DESCRIPTION OF REQUEST: Amendment to the Site Development Plan for Subdivision

**REASON FOR REQUEST
Administrative Amendment
Site Development Plan for Subdivision
The Bluffs at Encantado
Project #1004496, SU-1 RT Uses**

RE: Project 1004496-The Bluffs at Encantado
Site plan for subdivision, SU-1 for RT
Administrative Amendment (AA) and Environmental Planning Commission

Zone Map No. Sheet 2 of 2

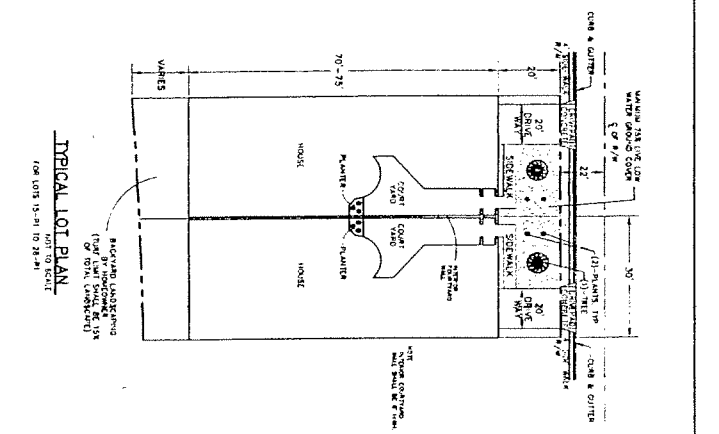
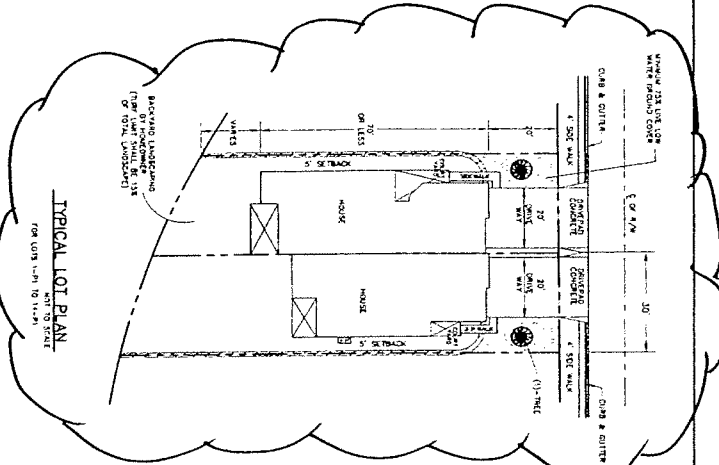
1. The building envelopes on Lots 1-P1 through 14-P1 have been modified to show seven (7) duplexes on the 14 lots, instead of the two groups of seven originally shown. The new layout will increase sightlines through the project and improve drainage.
2. There are no other changes on sheet 1. The number of lots, lot sizes and access remain unchanged.
3. On sheet 2 we have added a typical lot plan for lots 1-P1 to 14-P1 in addition to the previous typical lot plan which now applies only to lots 15-P1 to 28-P1.
4. The Design Requirements on sheet 2 have been revised to (new language is underlined):
 - a. Describe the changed unit configuration.
 - b. Decrease the minimum dwelling size from 2,000 square feet to 1,600 square feet.
 - c. The rest of the design requirements remain unchanged.
